DAMERON ESTATES SUBDIVISION

Engineering Comments: FINAL PLAT COMMENTS (should be addressed prior to submitting the FINAL PLAT for review and/or signature by the City Engineer):

APPLICATION NUMBER 4 DATE August 5, 2021

DETAIL SITE PLAN

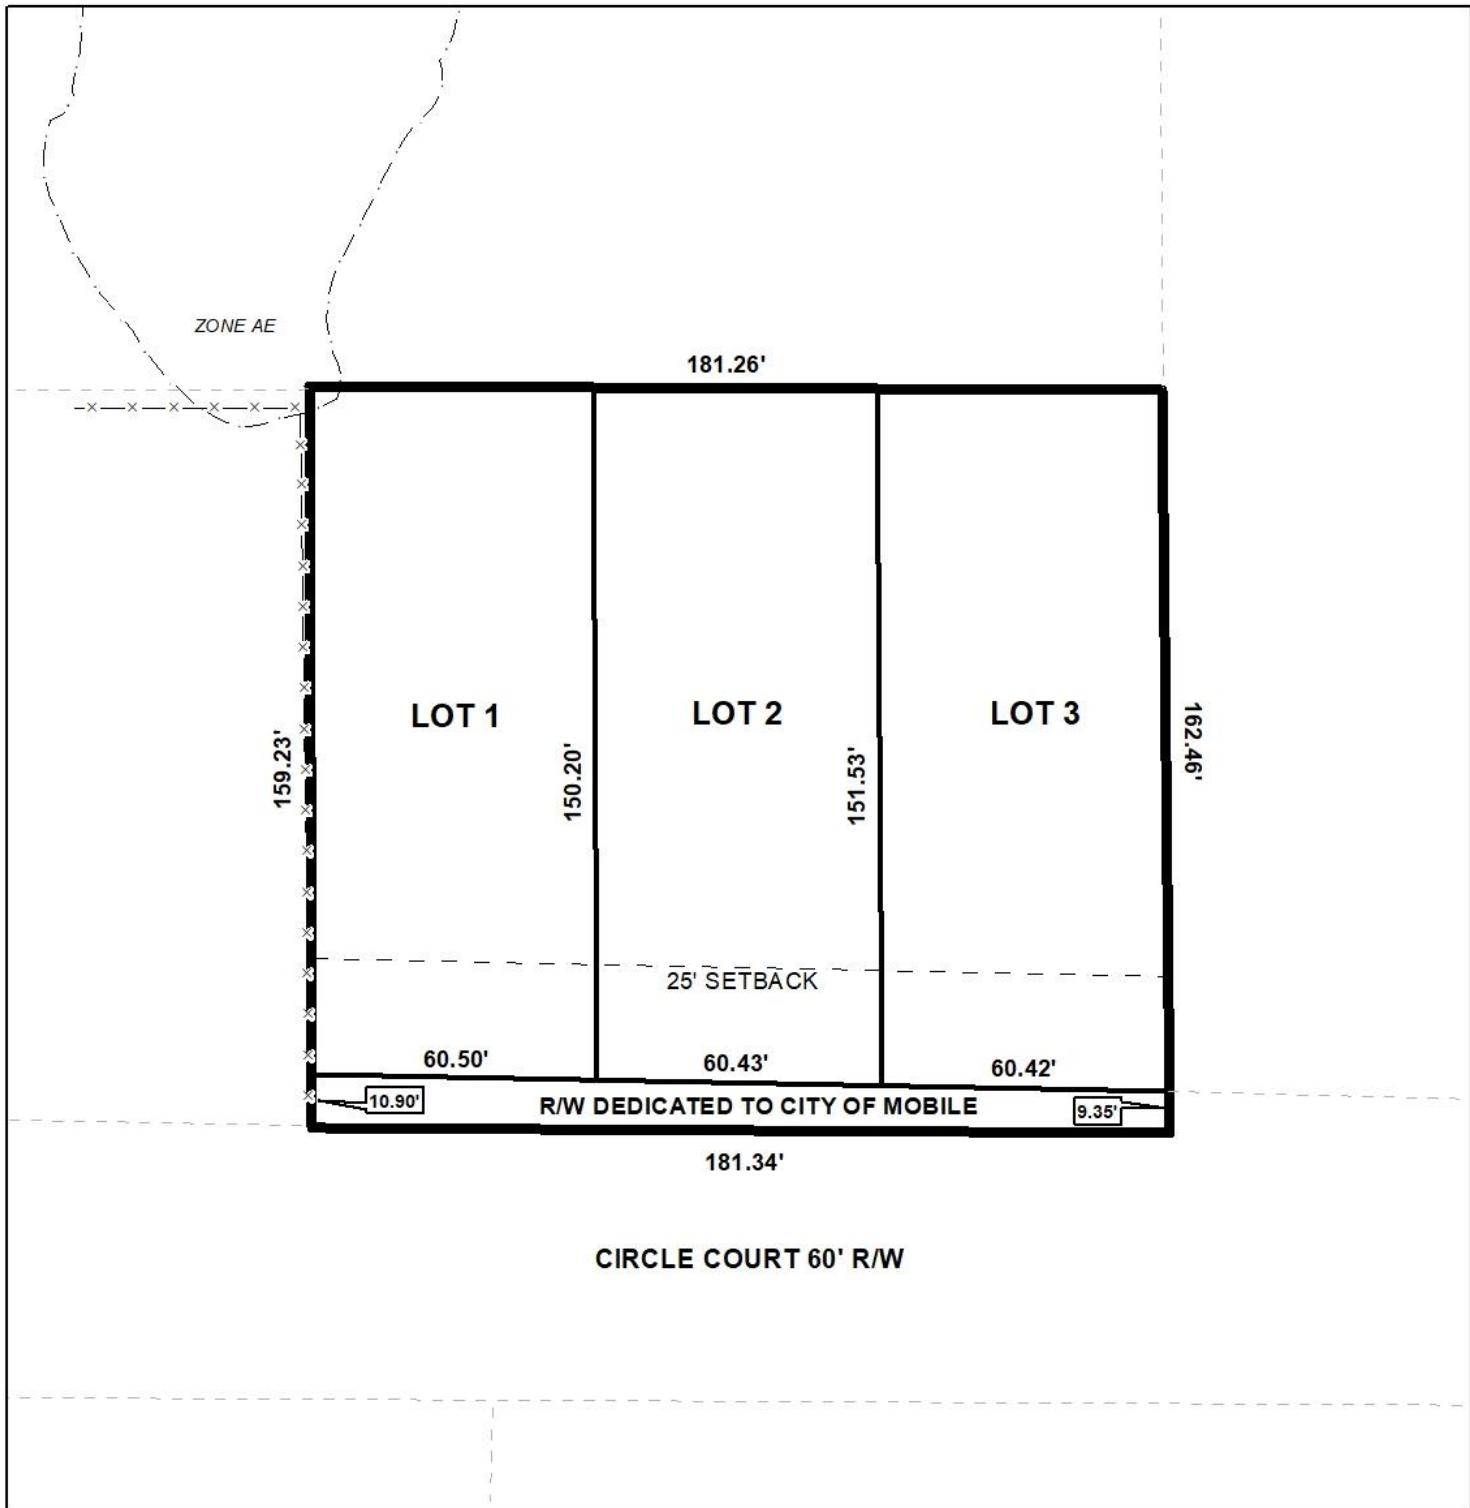
- B. Add legible street names to the vicinity map.
- C. Review and correct the written legal description or the written bearing and distance along the east property line of LOT 3.

- D. National Wetlands Inventory (NWI) mapping, as shown on City of Mobile GIS information, indicates that there is potential for wetlands within the property or properties shown on this plat. Show and label the delineated wetlands, or provide a note stating that the wetlands shown on this plat are scaled from the NWI data and have not been delineated.

- E. Provide the Surveyor's and Owner's (notarized) signatures.
- F. Add a note to the SUBDIVISION PLAT stating that as shown on the 1984 aerial photo (FLIGHT 26 - #89) LOTS 1, 2 & 3 will receive historical credit of existing (1984) impervious area towards stormwater detention requirement per Mobile City Code, Chapter 17, Storm Water Management and Flood Control) as follows: LOT 1 – NONE, LOT 2 – NONE, LOT 3 – 2,200 sf.

The site has frontage on Circle Court, a minor street without curb and gutter, and with a noncompliant 20 feet of right-of-way from the centerline. Minor streets without curb and gutter require a right-of-way with at least 30 feet from the centerline, and the plat indicates dedication will be provided to provide such. The preliminary plat incorrectly indicates a current right-of-way width of 60 feet for Circle Court. This would actually be the right-of-way width after dedication. The current right-of-way width of Circle Court should be indicated on the Final Plat, if approved.

The plat indicates a 25' minimum building setback line along Circle Court, as measured from required dedication, and this should be retained on the Final Plat, if approved. The proposed lots

meet the minimum size requirements of the Subdivision Regulations. As on the preliminary plat, the lot size labels in both square feet and acres should be retained on the Final Plat, or a table should be furnished on the Final Plat providing the same information.

As per the Traffic Engineering comments, the driveway number, size, location, and design are to be approved by Traffic Engineering and conform to AASHTO standards. A note should be required on the Final Plat stating these comments.

A previous structure was removed from the site between 2014 and 2017 without permits. If approved, an after-the-fact demolition permit should be required to be obtained prior to signing the Final Plat.

- 1) revision of the plat to indicate the corrected current right-of-way width of Circle Court on the Final Plat;
- 2) retention of the dedication to provide 30 feet from the centerline of Circle Court on the Final Plat;

- 3) provision of the right-of-way width of Circle Court on the Final Plat after dedication;
- 4) retention of the 25' minimum building setback line on the Final Plat as measured from required dedication;

- 5) retention of the lot size labels in both square feet and acres on the Final Plat, or the furnishing of a table on the Final Plat providing the same information;

- 6) obtaining of an after-the-fact demolition permit prior to signing the Final Plat;
- 7) compliance with the Engineering comments: *(FINAL PLAT COMMENTS (should be addressed prior to submitting the FINAL PLAT for review and/or signature by the City Engineer): A. Provide all of the required information on the SUBDIVISION PLAT (i.e. signature blocks, signatures, certification statements, written legal description, required notes, legend, scale, bearings and distances) that is required by the current Alabama State Board of Licensure for Professional Engineers and Land Surveyors. B. Add legible street names to the vicinity map. C. Review and correct the written legal description or the written bearing and distance along the east property line of LOT 3. D. National Wetlands Inventory (NWI) mapping, as shown on City of Mobile GIS information, indicates that there is potential for wetlands within the property or properties shown on this plat. Show and label the delineated wetlands, or provide a note stating that the wetlands shown on this plat are scaled from the NWI data and have not been delineated. E. Provide the Surveyor's and Owner's (notarized) signatures. F. Add a note to the SUBDIVISION PLAT stating that as shown on the 1984 aerial photo (FLIGHT 26 - #89) LOTS 1, 2 & 3 will receive historical credit of existing (1984) impervious area towards stormwater detention requirement per Mobile City Code, Chapter 17, Storm Water Management and Flood Control) as follows: LOT 1 – NONE, LOT 2 – NONE, LOT 3 – 2,200 sf. G. Email a pdf copy of the FINAL SUBDIVISION PLAT and LETTER OF DECISION to the Permitting Engineering Dept. for review at land.disturbance@cityofmobile.org prior to obtaining any signatures. No signatures are required on the drawing. H. After addressing all of the FINAL SUBDIVISION PLAT review comments provide the ORIGINAL (with all signatures except for the Planning*
